BACKGROUND INFORMATION FOR STANDARDS OF PERFORMANCE: COAL PREPARATION PLANTS. VOLUME 3. SUPPLEMENTAL INFORMATION

EPA-450/2-74-021-c

BACKGROUND INFORMATION FOR STANDARDS OF PERFORMANCE: COAL PREPARATION PLANTS VOLUME 3: SUPPLEMENTAL INFORMATION

Public Comment Summary: Coal Preparation Plants

Figure 1. Particulate matter emissions from thermal dryers.

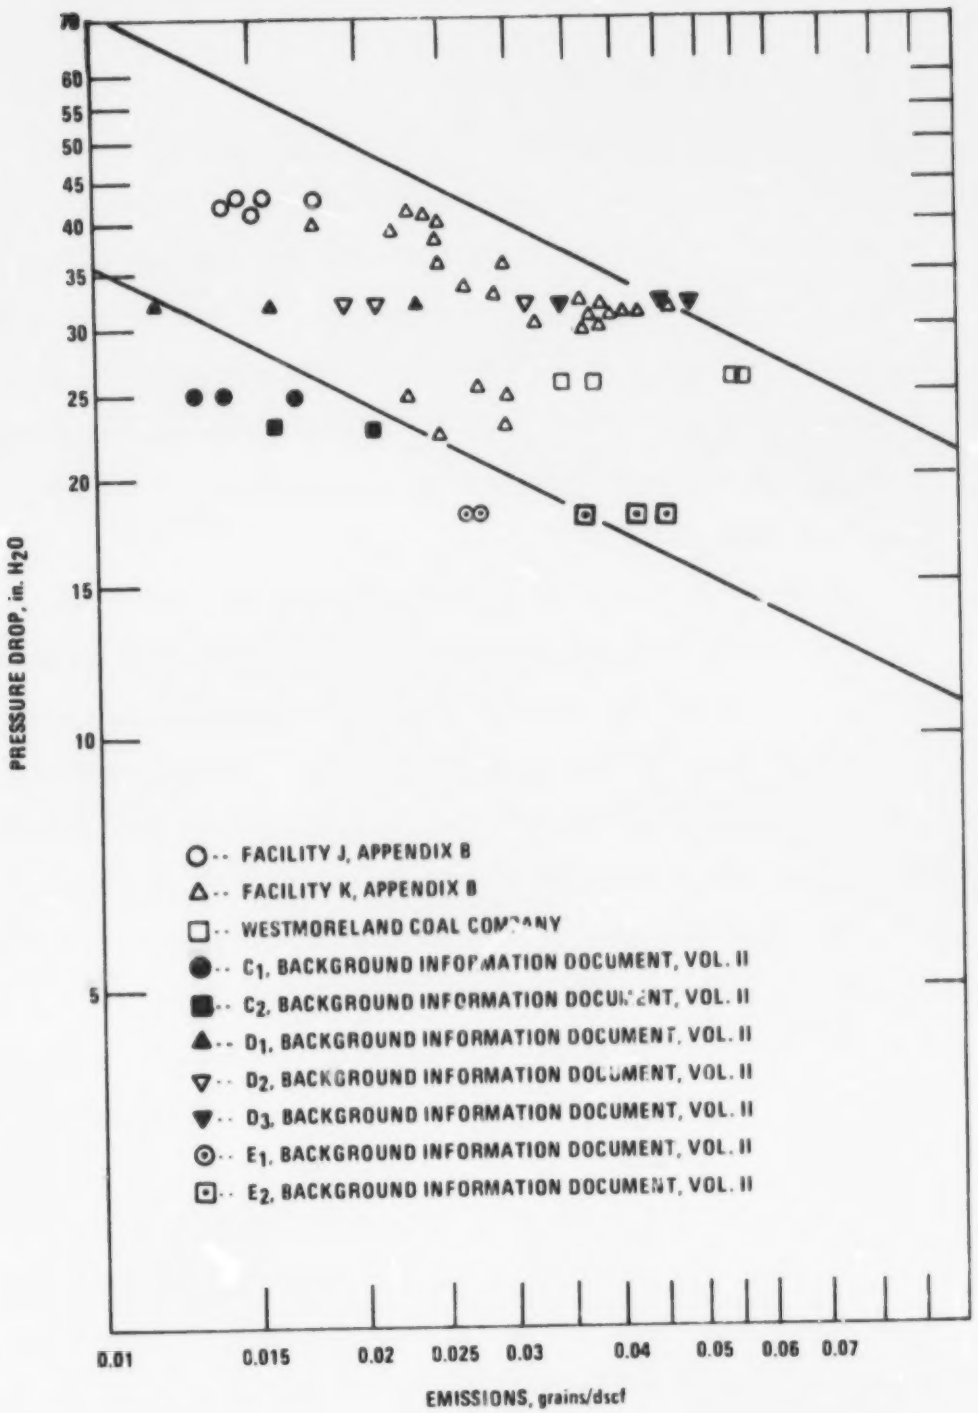
One commentator presented data and calculations which proposed to show that the coal processed by his company contained an unusually large proportion of very fine particles that would preclude attainment of the emission standards at reasonable pressure drops. These projections suggested that pressure drops of 50-52 inches of water gauge would be required to control thermal dryer particulate emissions processing this type of coal. Since this projection is considerably greater than the 25-35 inches projected in Volume 1 of the background information document, EPA decided to perform emission tests at the plant which processed the coal (Sewell seam) in question. The results of the EPA

Figure 1 encompasses all known extremes of particulate size and other variables that could significantly affect control equipment performance. Examination of Figure 1 shows that the mass emission standard is achievable with a pressure drop of 20 to 40 inches for a wide spectrum of coal types and processing techniques. The proportion of coal containing these very fine particles that is processed by a thermal dryer is within the control of the plant operator. These fine particles are separated from the remainder of the coal processed in the coal preparation plant and are concentrated in the froth flotation cells. The product coal from froth flotation-vacuum filtration circuits is commonly referred to as "filter cake." Depending upon the amount of moisture removal desired, to produce the final clean coal product, common practice within the industry is to dry none, part, or all of the "filter cake" material. EPA test data indicate that emissions from plants drying a fraction of the "filter cake" (Plant C) are near the lower (Figure 1), while emissions from plants drying all of the "filter cake" (Plant D) are nearer the higher line. The same type coal (Pocahontas) was being processed at each plant. These results (C_1, C_2 and D_3) are contained in volume 2 of the background information document. In addition to

The question of drying none, part or all of the filter cake material is a matter of balancing economic considerations, product specifications, and desired emission control. Even if all filter cake and emissions are nearer the upper line, Figure 1 indicates that the pressure loss needed to attain the promulgated standard of 0.031 gr/dscf will be 40-45 inches for the most extreme circumstances. This projection has been confirmed by data developed by a major scrubber manufacturer from extensive control equipment tests.[4] Pressure drops of this magnitude and greater are technically feasible. The economic aspects of this reevaluation are discussed in Sections IV and V.
